Re: Tarmac America, Inc. - Titan King Road Mine
File No. 0244771-002, Levy County

**REQUEST FOR ADDITIONAL INFORMATION
ENVIRONMENTAL RESOURCE PERMIT APPLICATION**

Re: Tarmac America – Titan King Road Mine
File No. 0244771-002, Levy County

Figure 1A: #34 Withlacoochee Bay Shellfish Harvesting Area and proposed mine site location

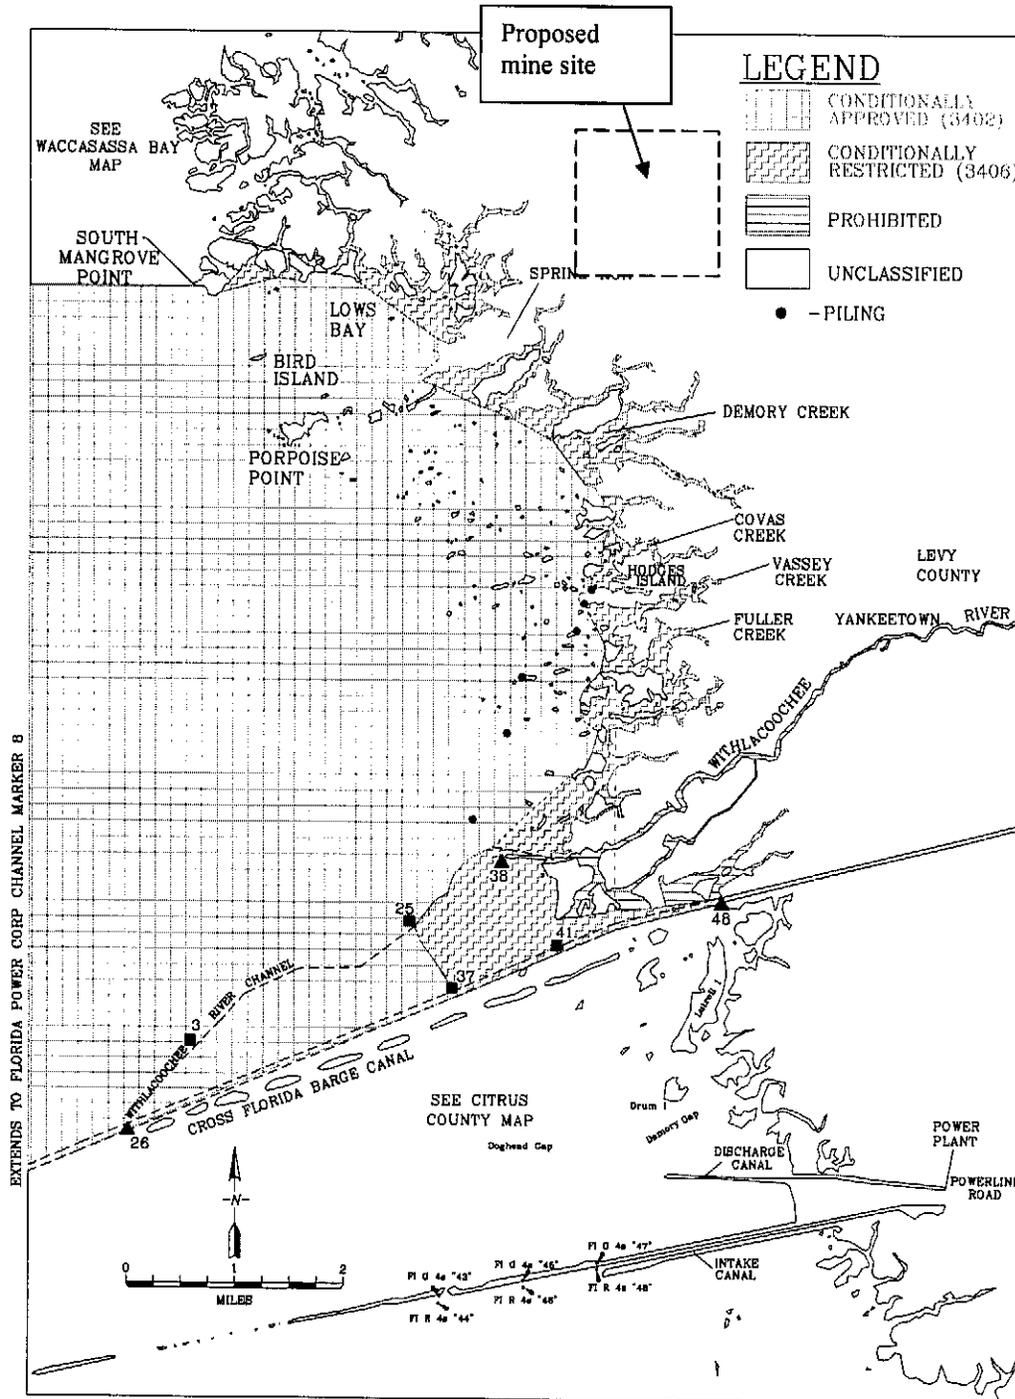
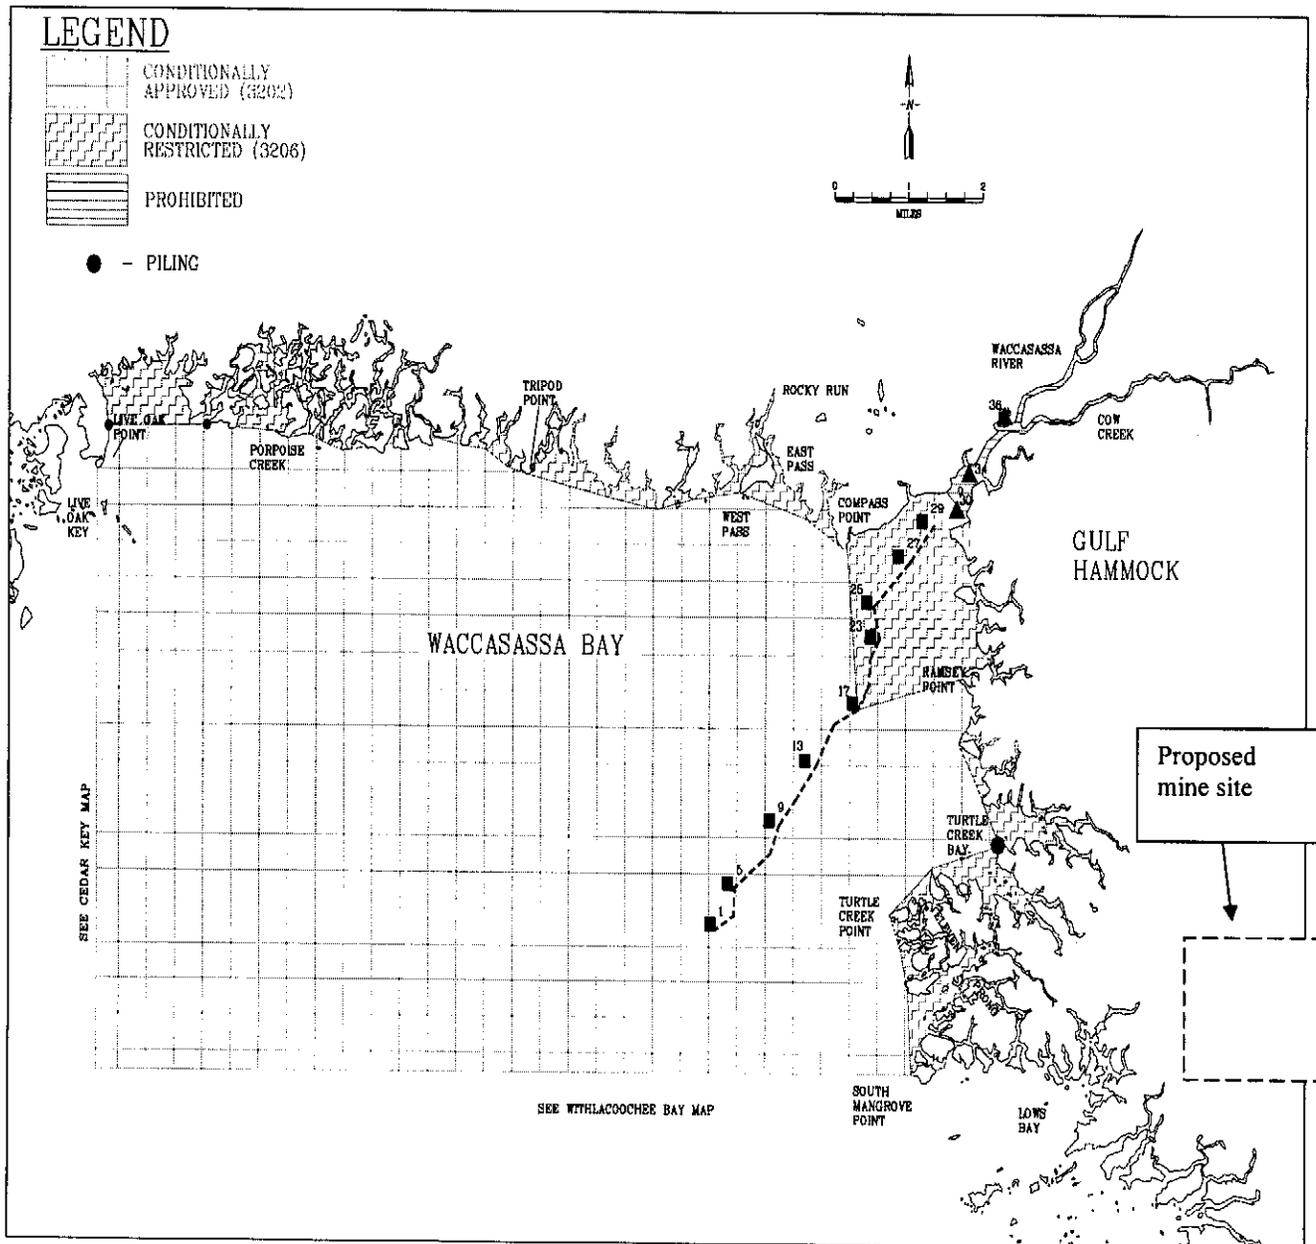
The proposed project consists of the construction and active use of a limerock mine to provide road and construction material. The location of the proposed project is shown on the attached figures of shellfish harvest area classifications (Figure 1A and 1B). The basis for the following comments by the Shellfish Environmental Assessment Section is solely on shellfish water classifications. The Florida Fish and Wildlife Conservation Commission should be contacted to address any potential impacts to shellfish resource and propagation.

The daily activities of the mining operation should not directly affect the waters of Withlacoochee Bay Shellfish Harvesting Area (SHA) under normal conditions. However, due to the proposed mine site being located adjacent to the coastal marsh, there is the potential for indirect impacts to the shellfish growing waters. Indirect impacts to the shellfish harvesting areas may be conveyed through groundwater or stormwater runoff. The entire proposed mine site is located within the 100 year floodplain (Figure 3). In addition, the proposed mine site is within the storm surge zone for Levy County, with the western extent of the site being within the Tropical Storm surge category (Figure 2). There are also numerous tidal creeks meandering through the coastal marsh adjacent to the site. The greatest potential impact to shellfish waters would occur during flood events caused by both heavy rainfall and during coastal flood events. There is a potential for pollutants to enter the coastal tidal creeks and eventually the shellfish harvesting waters both through surface waters and through sheet flow (groundwater). However, it is not known to what extent if any it will have on the management of the Waccasassa Bay and Withlacoochee Bay Shellfish Harvesting Areas. In the near term, reclassification of the shellfish harvesting areas does not appear necessary to prohibit shellfish harvesting if the mine is built as proposed. However, if the proposed mine negatively impacts either of the two SHAs by degrading water quality, reclassification of the affected SHA(s) would be required.

Figure 2. Storm Surge Zones for Levy County

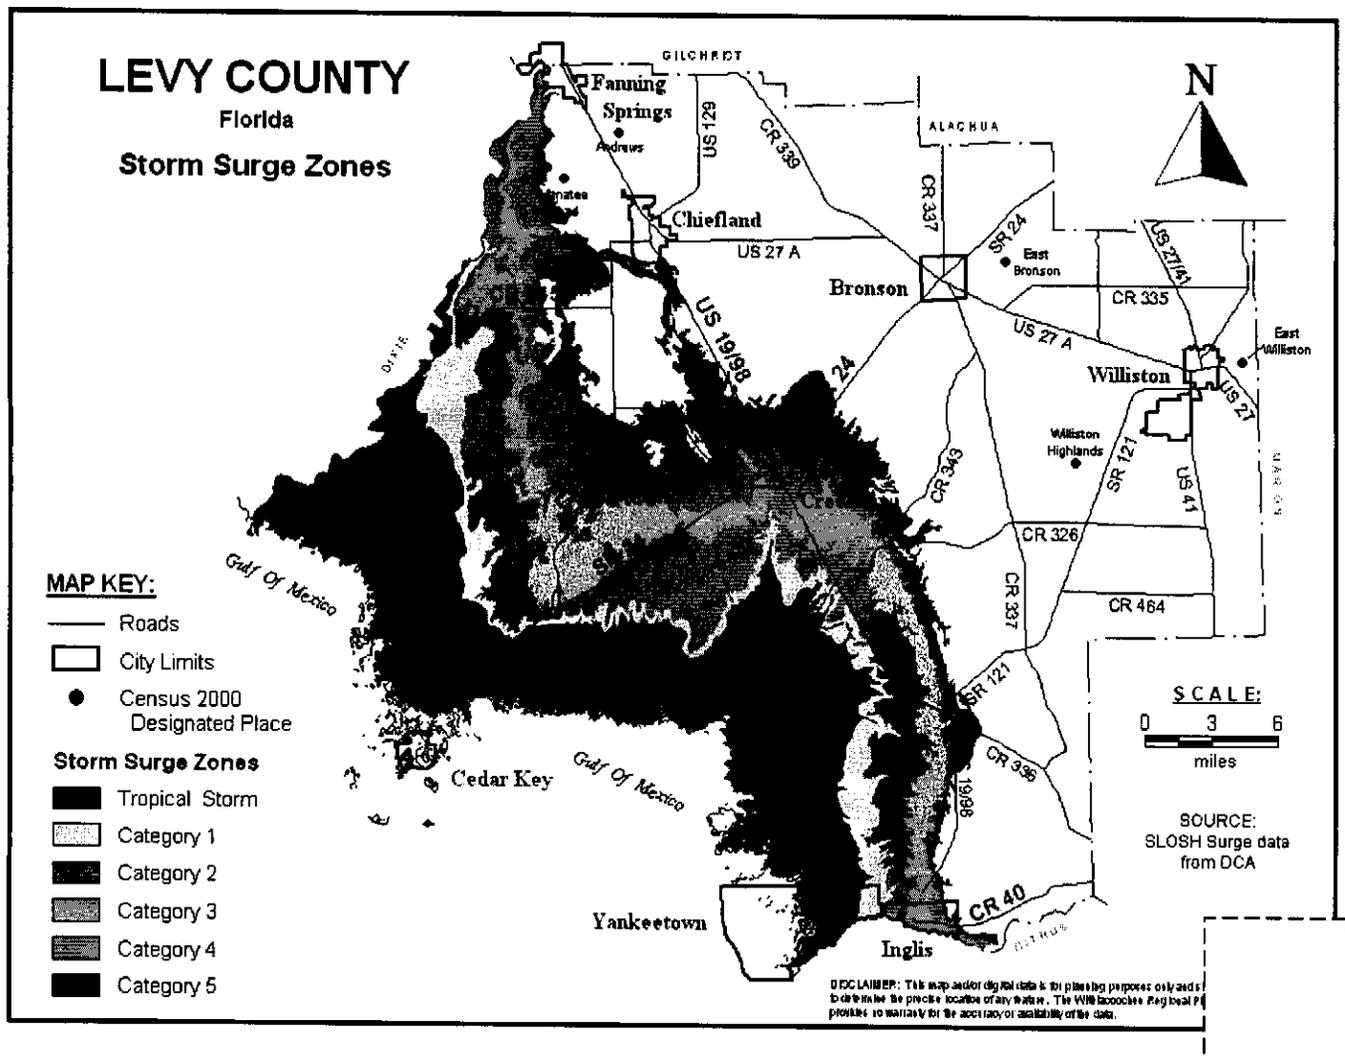
The proposed project is located in a Coastal High Hazard Zone. Please provide reasonable assurance that the Aquatic Preserve will not be subjected to significant adverse impacts during these events. Please take into account 100 year storm events to demonstrate reasonable assurance. Flushing of sediments and pollutants during these events has the potential to alter natural existing benthic habitats, bathymetry, and water quality of the Aquatic Preserve.
